LONG ISLAND LIGHTING COMPANY

SHOREHAM NUCLEAR POWER STATION

SNRC-1141

Fire Protection
Shoreham Nuclear Power Station - Unit 1
Docket No. 50-322

FLOW DIAGRAM
WATER FIRE PROTECTION SYSTEM
SHOREHAM NUCLEAR POWER STATION
UNIT 1
LONG ISLAND LIGHTING COMPANY
 STONE & WEBSTER ENGINEERING CORPORATION
 BOSTON, MASS.
 LILCO
 DRAWING NUMBER **M-10661-12**

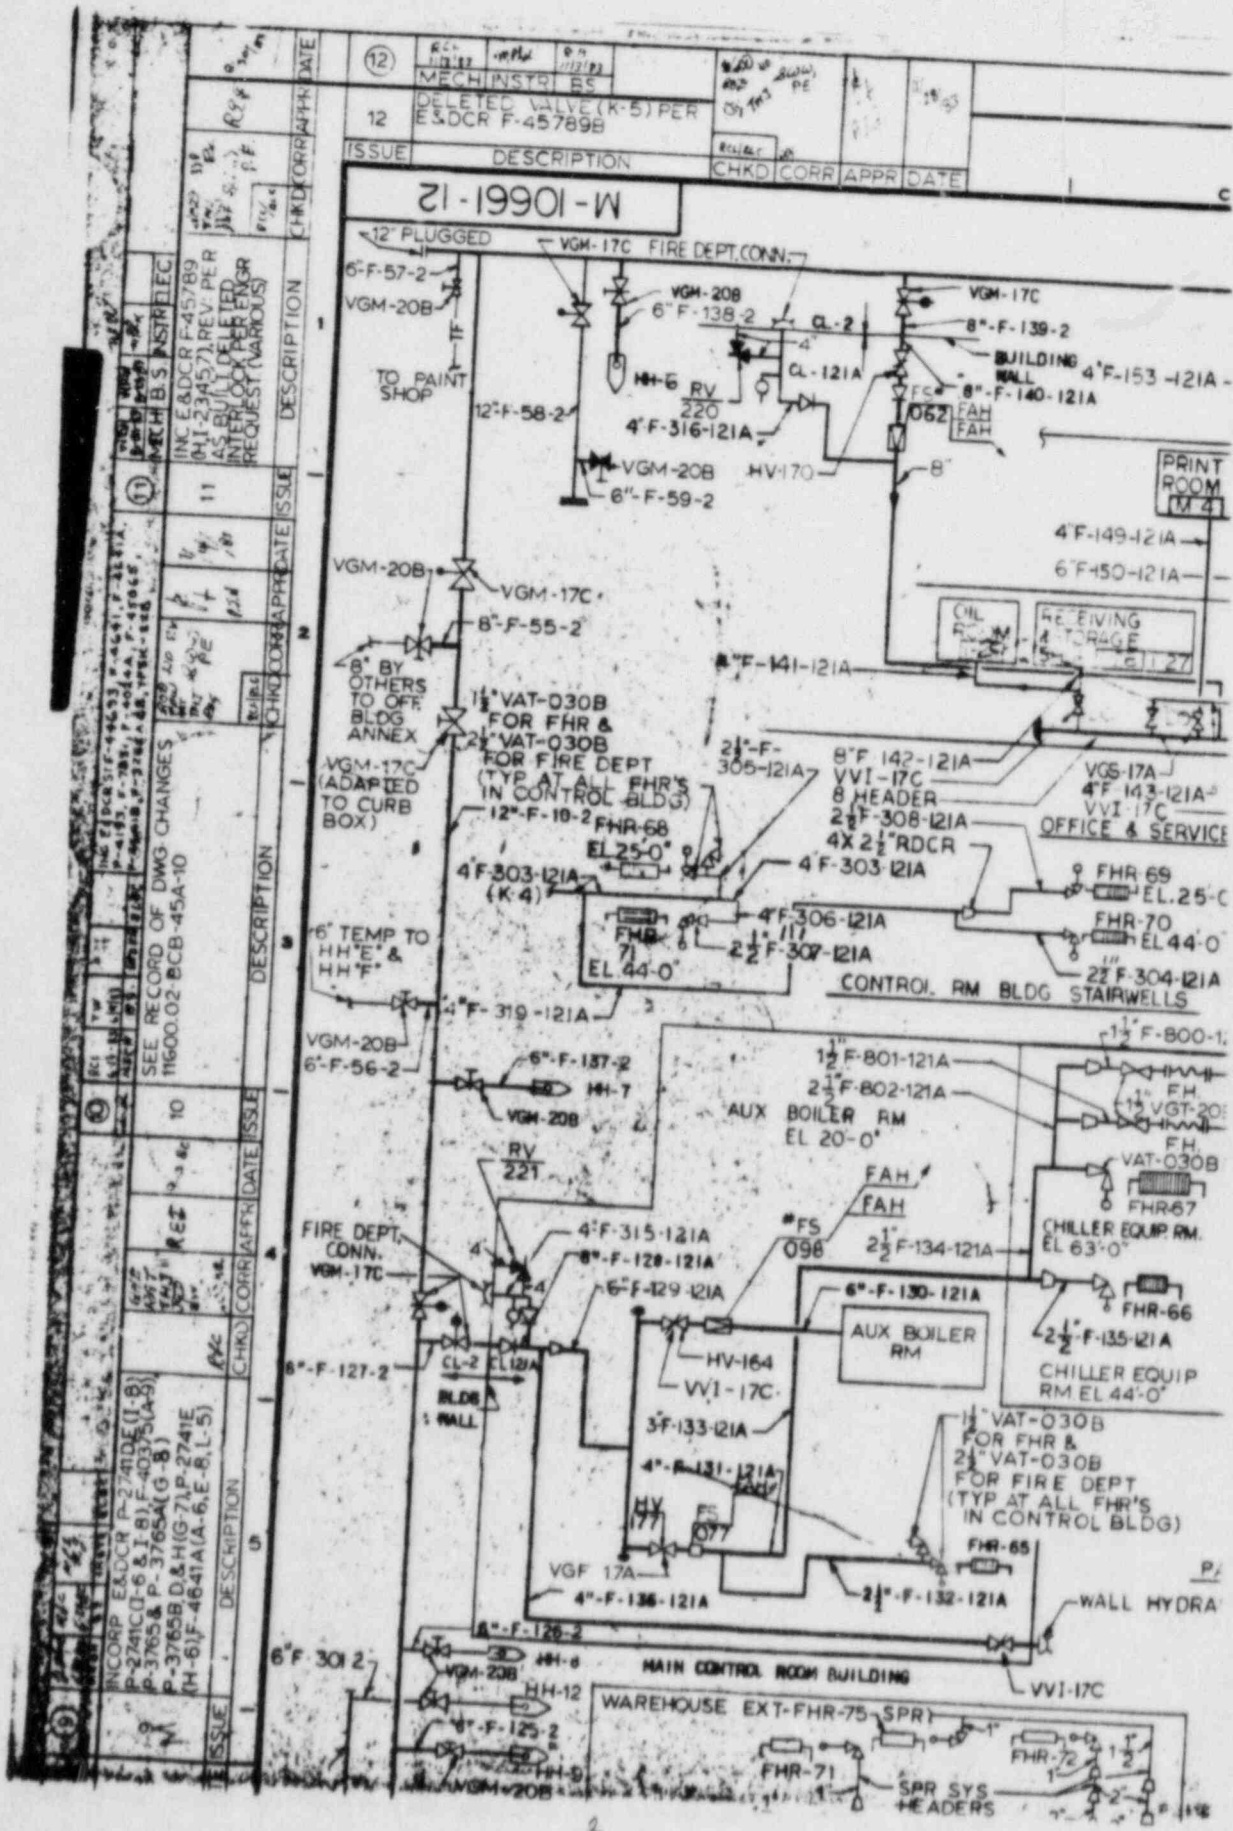
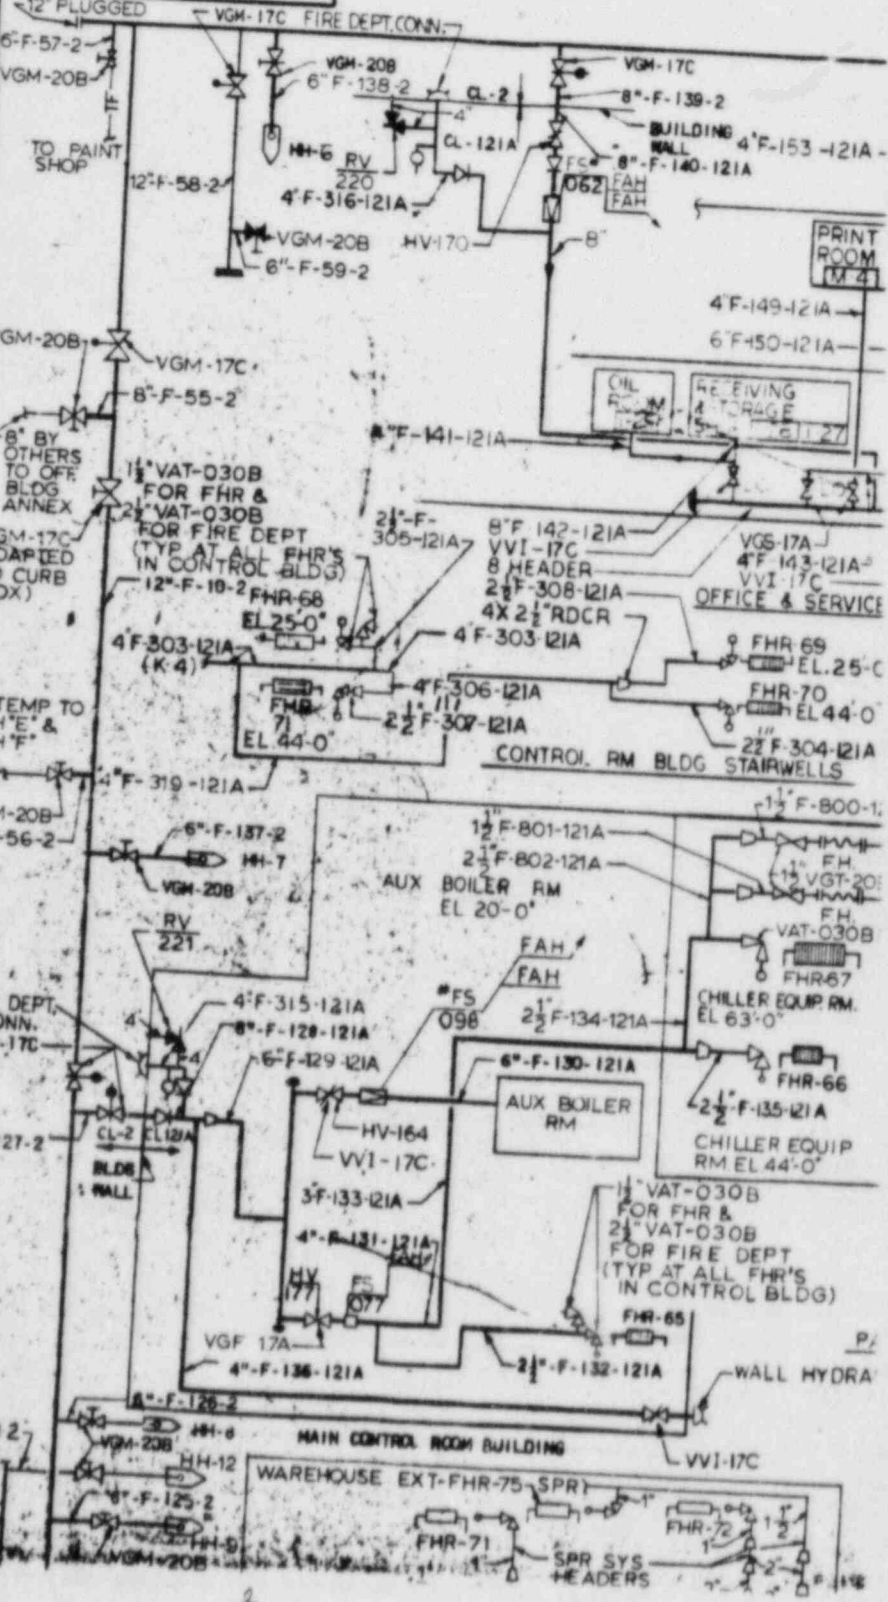
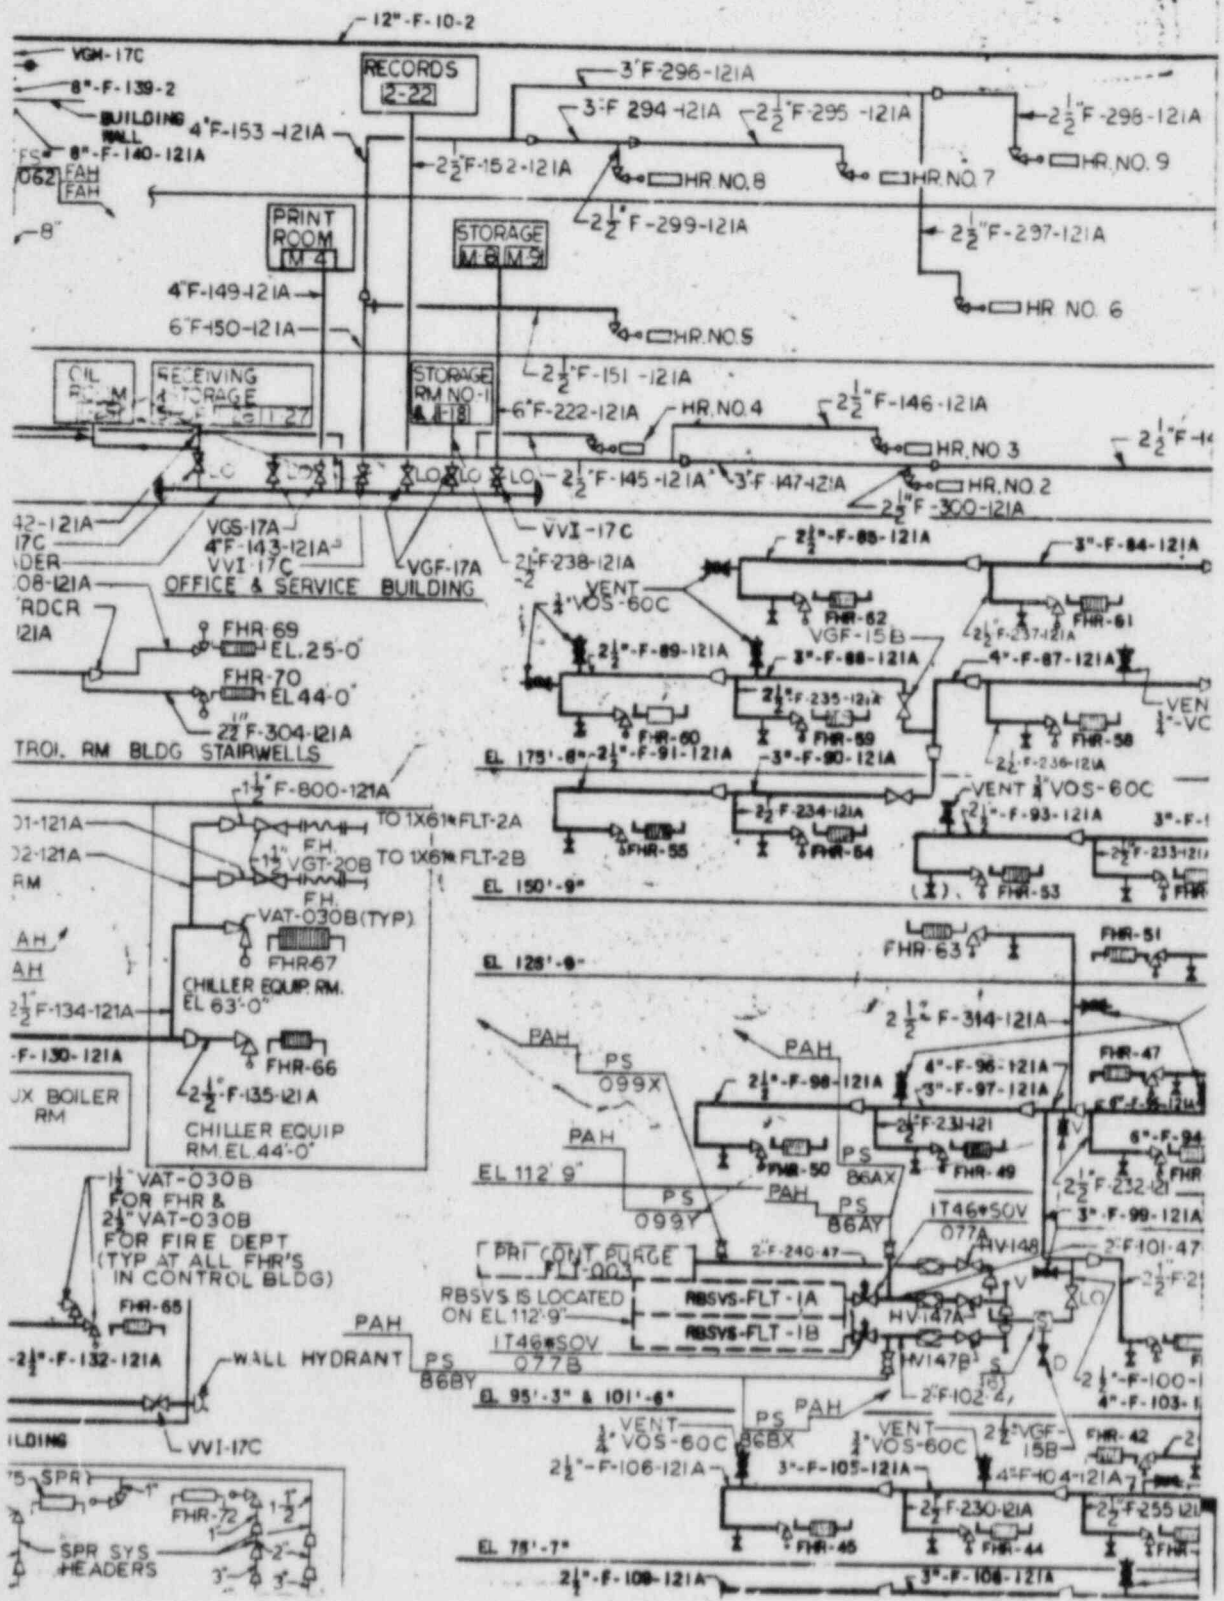
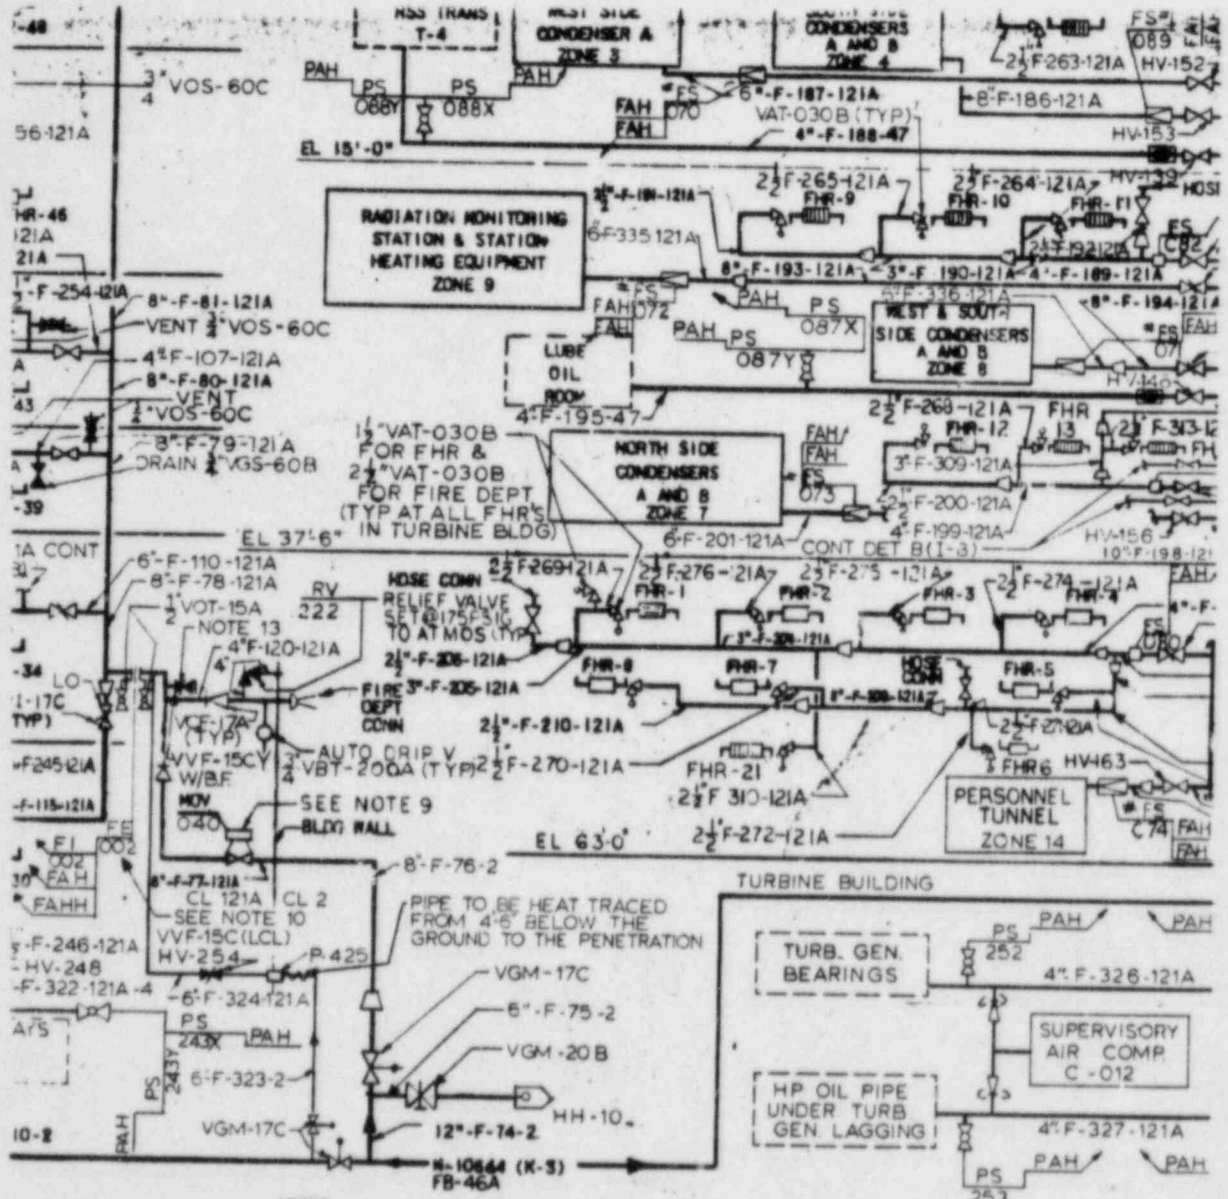
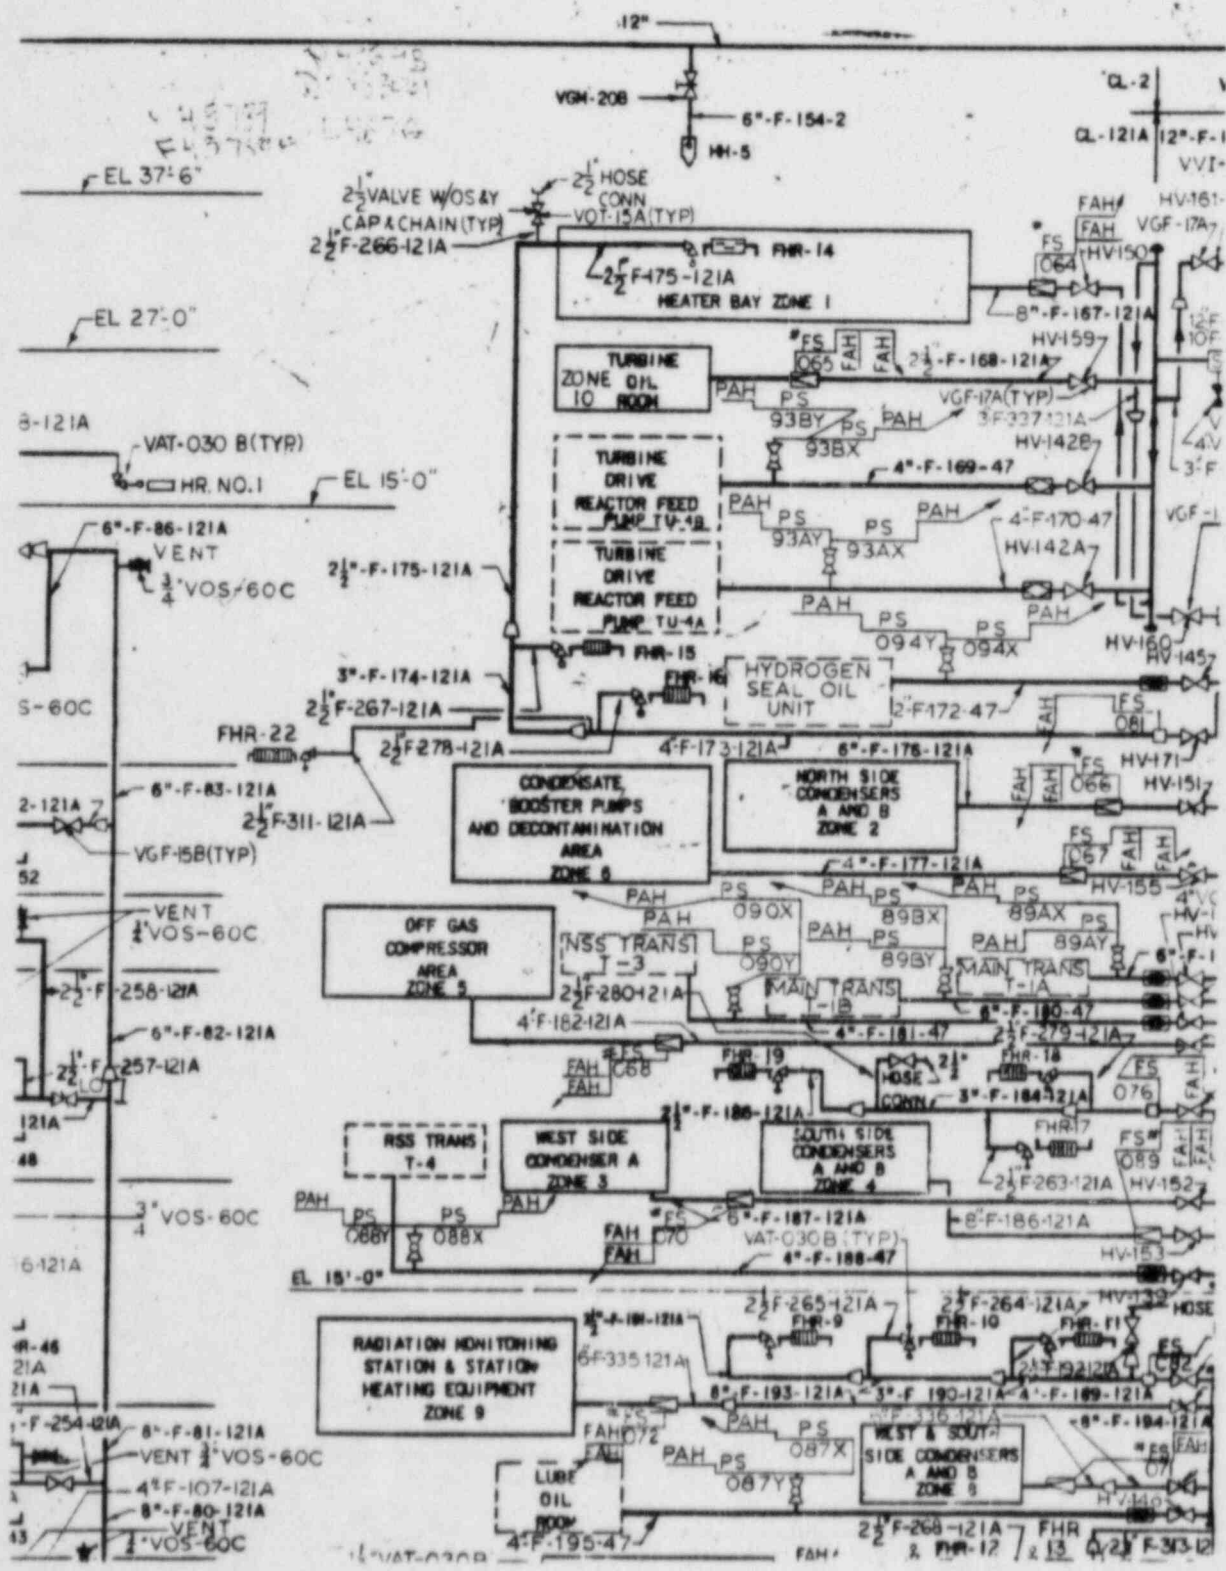
Unresolved Item 84-46-14 - Single Header in the Reactor Building

Branch Technical Position 9.5-1 Appendix A requires that a single failure not impair the fire suppression system. LILCO complies with the BTP. With respect to the single header in the Reactor Building, LILCO has utilized the guidance of MEB-1 in determining that the postulated pipe failure for this moderate energy system would result in a crack producing a leakage of 165 gpm. Such a failure would not impair the fire suppression system in the Reactor Building since each fire pump has a rated capacity of 2500 gpm.

The single header configuration utilized at Shoreham was inspected and reviewed by the NRC during the FSAR review process (1979-1980). As a result of a staff question (FHAR Question 1), a redundant feed to the Reactor Building was installed. With this modification, the Staff accepted the design of Shoreham's fire header for the Reactor Building.

A copy of drawing M-10661, Rev. 12, "Water Fire Protection System" is enclosed, showing the water suppression system in the Reactor Building. Shoreham Technical Specifications require that if the fire suppression water system becomes inoperable, a backup fire suppression water system must be established within 24 hours. From the enclosed figure it can be seen that certain non-postulated circumferential breaks in the Reactor Building could be isolated and backup suppression established via hose reels or extinguishers. Depending on the location, certain other non-postulated breaks could render the fire suppression system temporarily inoperable. If backup suppression could not be established, LILCO would bring the plant to the shutdown condition.

The FSAR has always contained the single header configuration. The NRC accepted this configuration and LILCO believes that a backfit is not justified.
